ALPINE CITY COUNCIL PUBLIC HEARING & MEETING

NOTICE is hereby given that the **CITY COUNCIL** of Alpine City, Utah will hold a **PUBLIC HEARING and a REGULAR MEETING** on **Tuesday, November 11, 2014 at 7:00 pm** at Alpine City Hall, 20 North Main, Alpine, Utah as follows:

- D. Ilangeni Estates Plat Amendment - Three Falls Ranch Preliminary Plan - Fort Canyon:** The City Council will review the proposed Three Falls Ranch PRD preliminary plat consisting of 54 lots on 725 acres located at the north end of Fort Canyon Road.
- E. Open Space Discussion**
The City Council will discuss Open Space in Alpine City including the advantages and disadvantages of public and private open space and review a recommendation made by the Planning Commission.

PINE GROVE LOTS 1 & 3 ZONE CHANGE Vicinity Map

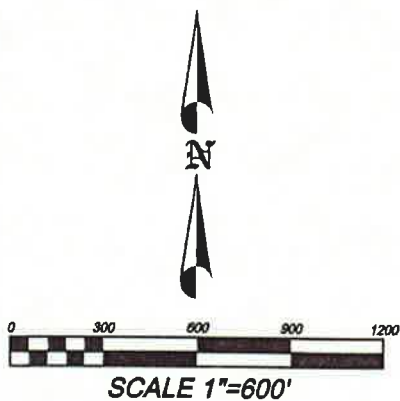
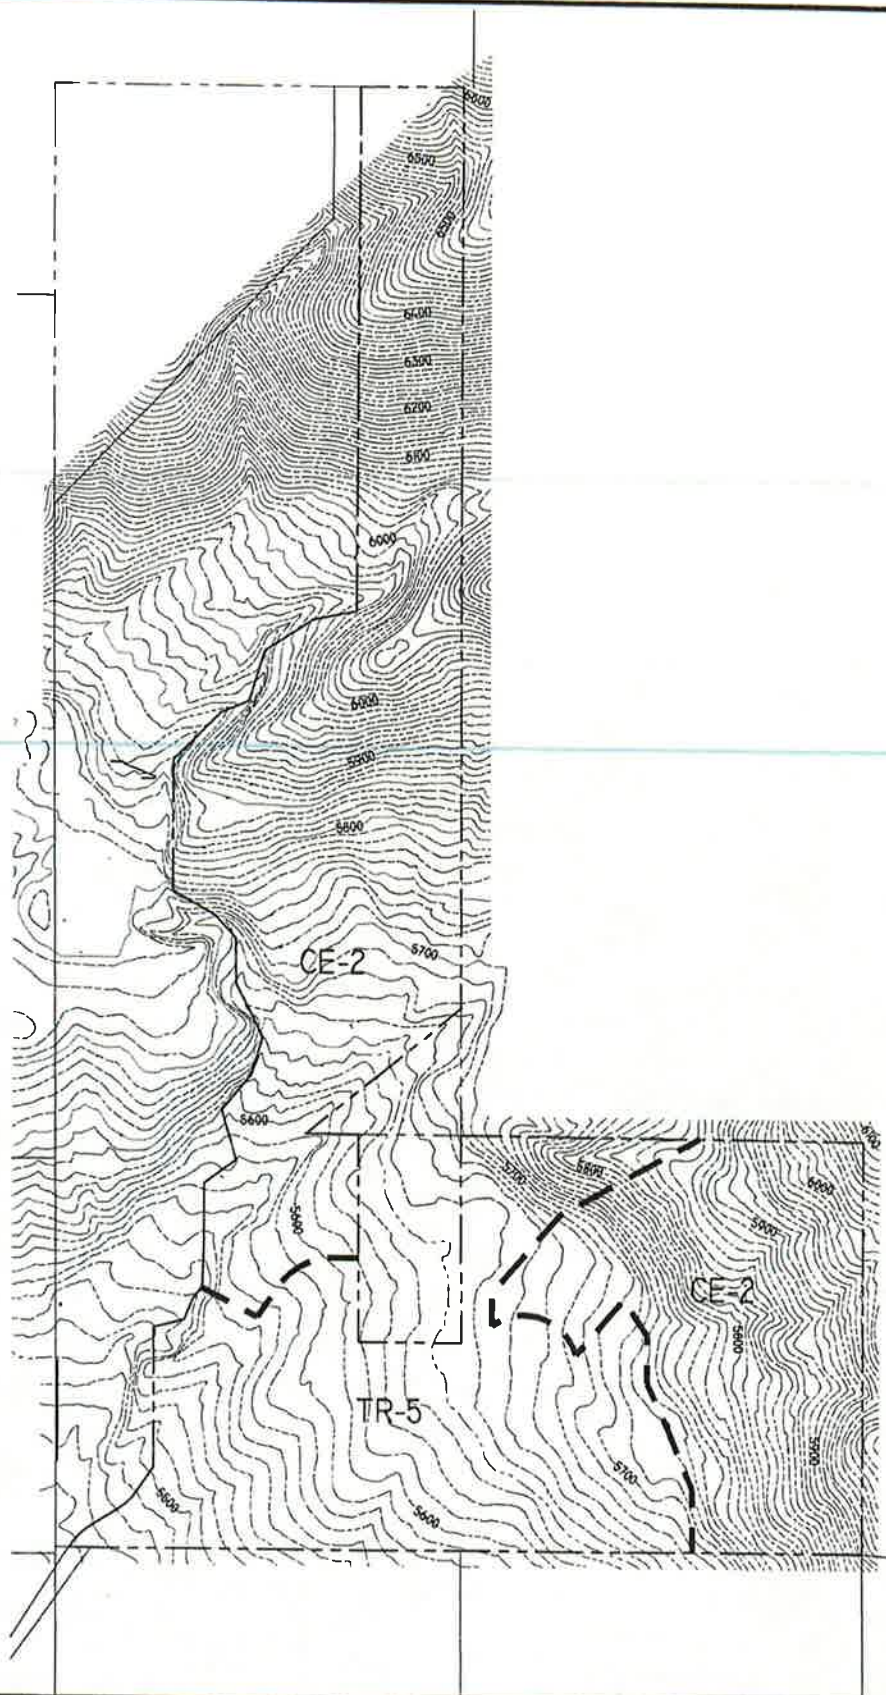
- 1) I've noticed this area is not included in Alpine City's annexation policy declaration area. Has this area even been included in an annexation petition or application to be included within Alpine's annexation policy declaration area? (I've attached the applicant's vicinity map for reference.)

- 2) What is Alpine's general level of support for this zone change request? The current zoning has a minimum lot size of 50 acres. The proposed TR-5 zoning would have a minimum lot size of 5 acres, unless a central water system is provided, in which case the minimum lot size is 20,000 square feet. The CE-2 Zoning has a minimum lot size of 20 acres, with higher densities provided for certain types of developments (mountain home development, recreational resort). One of the stated purposes of the TR-5 Zone is to facilitate annexation, so Alpine City's input on this request is helpful. (I've attached the applicant's proposed zoning map for reference.)

Answer: This area has been included in an annexation petition in the past and at one time was in Alpine's annexation policy declaration area. An annexation petition for this area, which the City calls the Pine Grove area, was considered by the City in the 1990's but no agreement between the City and the landowners could be reached on the appropriate density for this property if it were to be annexed into the City. This disagreement resulted in a lawsuit by the landowners which was eventually settled in 2011. As part of that settlement the City did agree to provide culinary water "service for three and only three culinary water connection(s) for Pine Grove". It has not been a part of Alpine's annexation policy declaration area for a number of years.

Answer: (This is the purpose of this agenda item.)

THREE FALLS RANCH
PRELIMINARY PLAT
FORT CANYON ROAD EXHIBIT

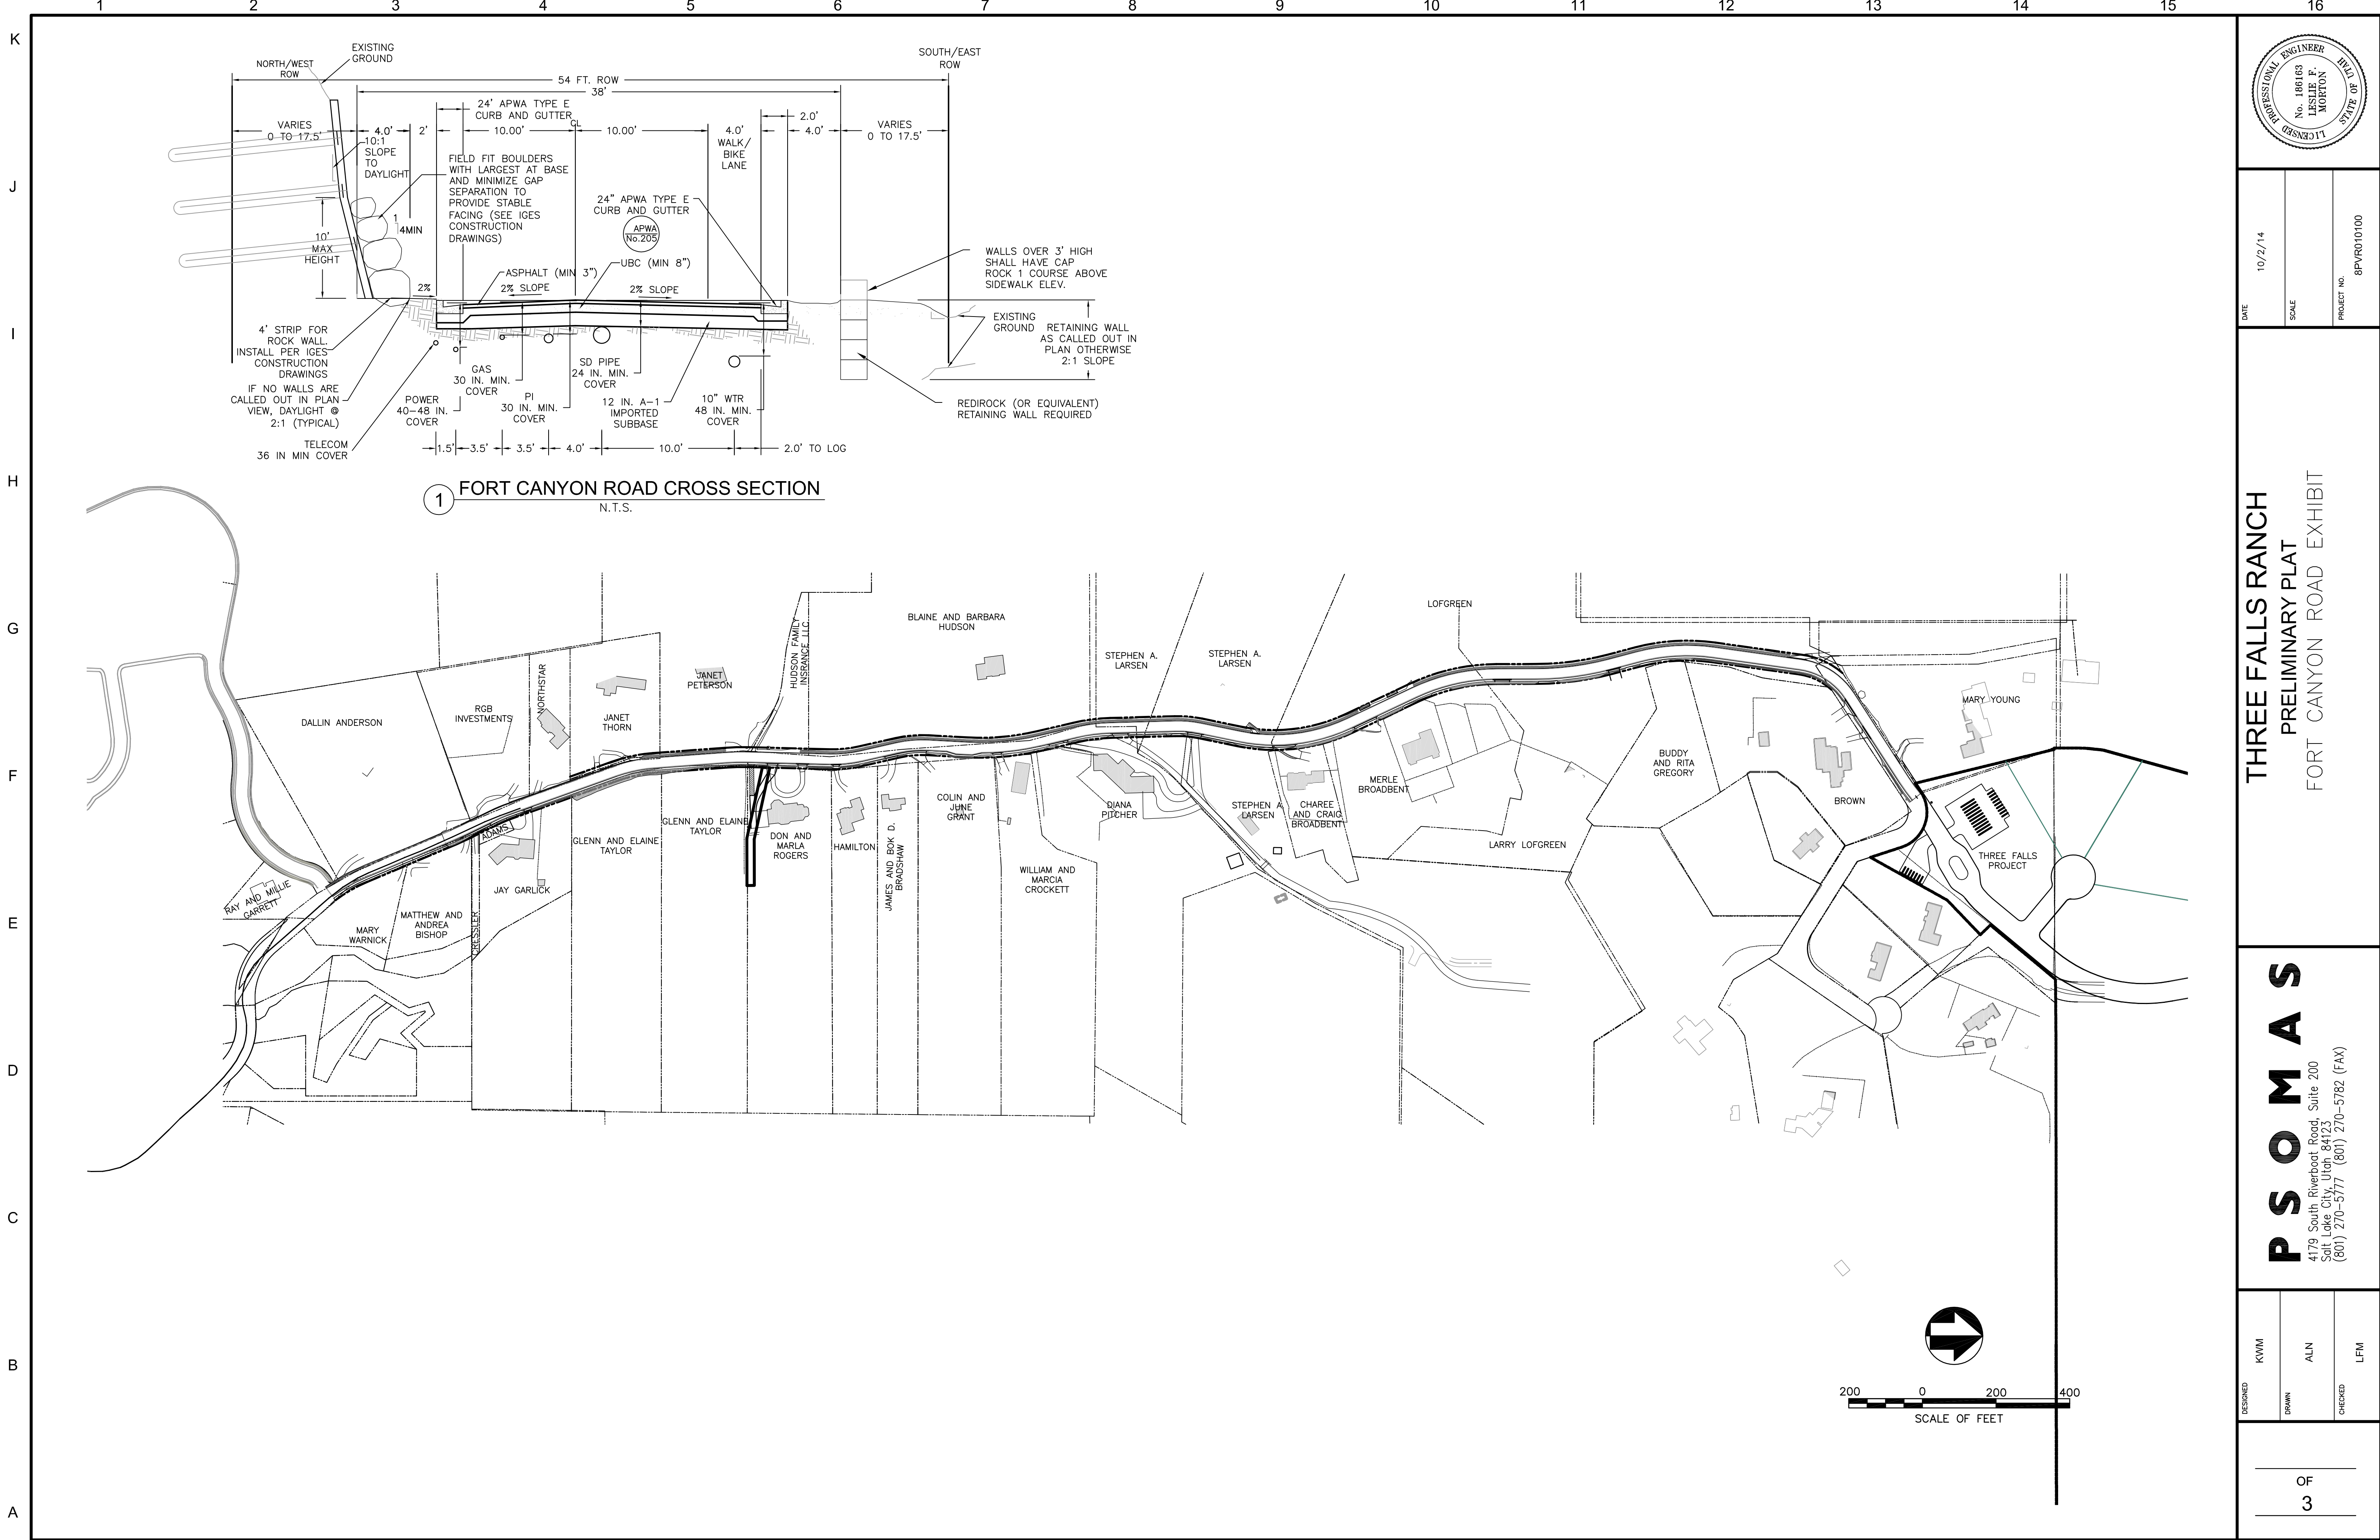
- Sheet 4: Lot 9, The owner of this lot does not want to be a part of the Three Falls Ranch Subdivision, but wants the lot to remain as it is in the Ilangheni Estates Subdivision. If the lot has to be recorded as part of the Three Falls Ranch Subdivision, the issue is that there is more than the allowable percentage of 25 percent slope included in the lot. This item may or may not require an exception.

- The development code limits grades through intersections to 3% for 50 feet each way from the intersection. This proved difficult on several intersections throughout the development. Following is a list of intersections where exceptions have been requested that exceed the maximum allowable grade through the intersections:
 - Sheet 13: Proposes a 5% grade on Three Falls Way at Fawn Meadow.
 - Sheet 16: Proposes a 5% grade on Three Falls Way at the intersection of Summerfield Court and at Snow Meadow Drive/Mountain Park Drive.
 - Sheet 18: Proposes a 5% grade on Mountain Park Drive at the intersection with Three Falls Way.
 - Sheet 18: Proposes a 4% grade on Snow Meadow Drive at the intersection with Three Falls Way.
 - Sheet 35: Proposes a 5% grade on Snow Meadow Drive at the intersection with Sliding Rock Ridge.

- Sheets 30-32, 32A: On August 28, 2007, the City Council granted an exception to allow the secondary access to have 20-feet of pavement with curb and gutter on both sides. In addition, an exception was granted to allow 80-foot centerline radii.
- The cul-de-sac called Daybreak Way exceeds the 450 foot maximum length. The DRC recommended that an exception be granted for this cul-de-sac, and the Planning Commission recommended the exception be approved at their September 20, 2005, meeting. The City Council has not acted on this exception.
- The Hillside Protection Ordinance limits the height of structures in this area to 25 feet. Due to the location of the development not being visible from other parts of the City, the DRC and the Planning Commission have recommended that the structures be allowed to be up to 34 feet in height, as they are in other parts of the City.
